HISTORIC AND DESIGN REVIEW COMMISSION

HDRC CASE NO: 2016-276

ADDRESS: 201 W COMMERCE ST **LEGAL DESCRIPTION:** NCB 122 BLK LOT 1 & 2

TYPE OF WORK: Installation of a storefront system

FORMER KRESS BLDG. - DOWNTOWN S.A. EXISTING FACADE

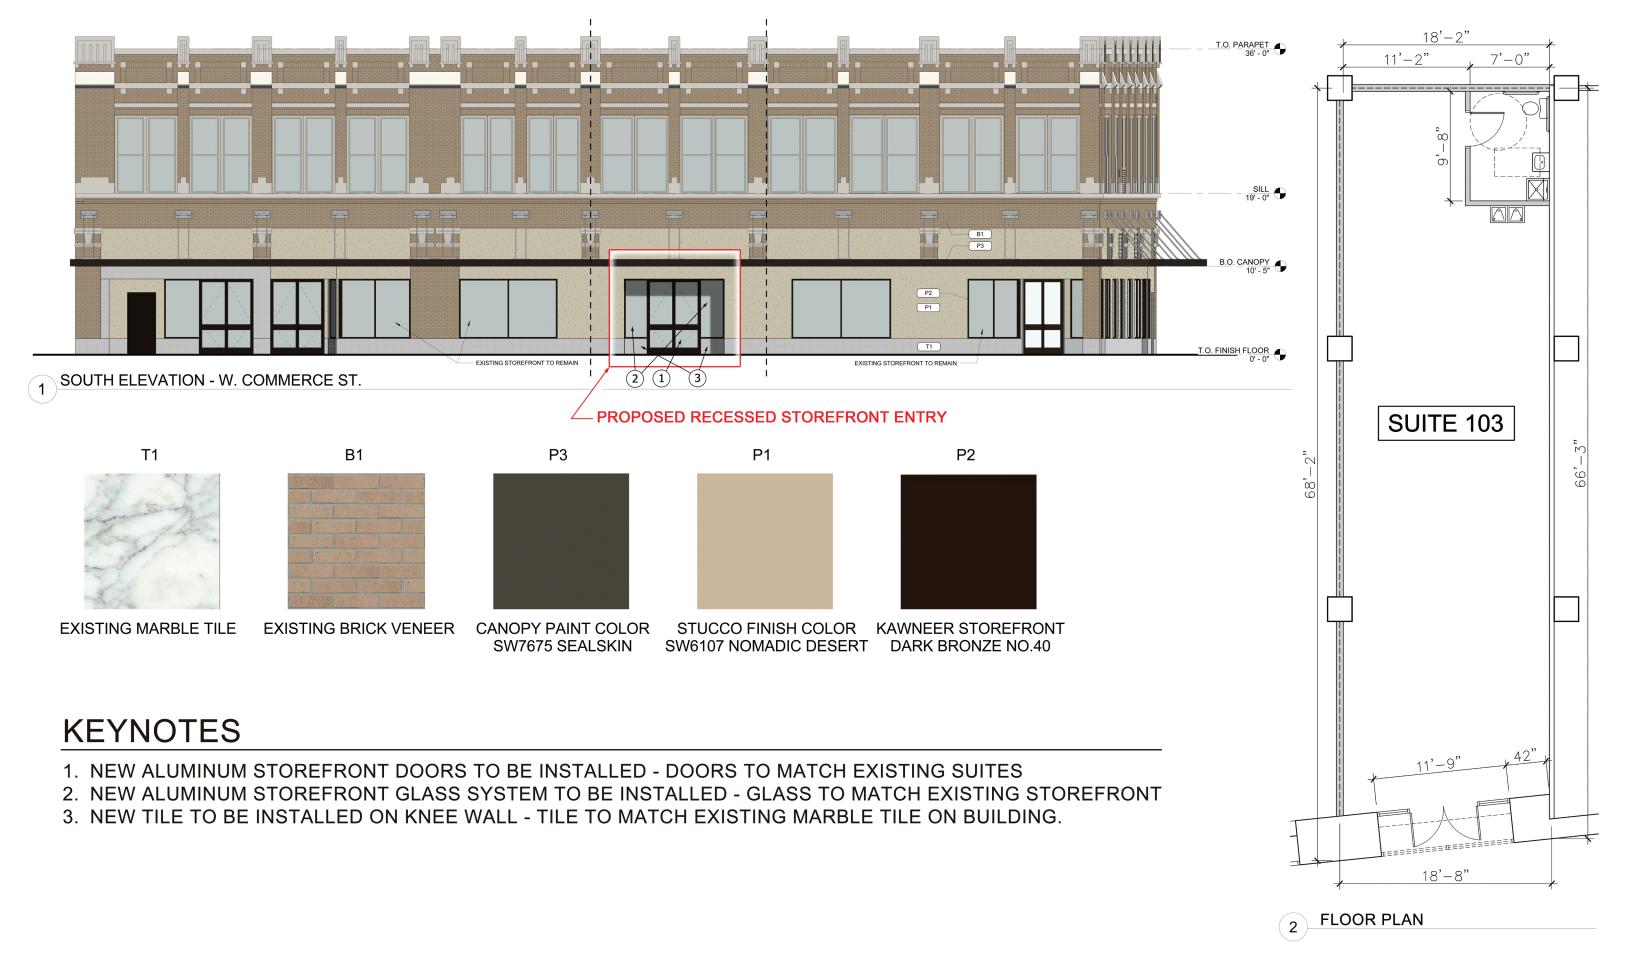
- a. The structure at 201 W Commerce was constructed circa 1900, features a canopy which covers the sidewalk on both the south and east facades of the structure, a brick and stucco façade and wood windows. The original brick façade exists above the canopy, however, non-original stucco and aluminum storefront systems are the primary materials on the south façade below the existing canopy.

- b. The applicant has proposed to modify the existing façade at suite 103 on the south façade of the structure by creating a new entrance which is to include an aluminum storefront system. The applicant has noted that the proposed entrance will be recessed from the existing exterior wall plane. According to the Guidelines for Exterior Maintenance and Alterations, new features that alter, destroy or disrupt the rhythm of a historic façade should not be introduced to a historic structure. The applicant has proposed to introduce the entry system in a location that

- currently features existing, non-original openings. Staff finds that the applicant's proposal to modify an existing, non-original opening appropriate.

- c. As previously mentioned, the façade below the existing canopy features marble tile, stucco and aluminum storefront systems, none of which are original. The applicant has proposed to match the existing finishes and materials for the proposed recessed storefront system. Staff finds this appropriate.

Staff recommends approval based on findings a through d with the stipulation that archaeological investigations are required for all excavations. The archaeological scope of work should be submitted to the OHP archaeologists for review and approval prior to the commencement of field efforts. The development project shall comply with all federal, state, and local laws, rules, and regulations regarding archaeology.
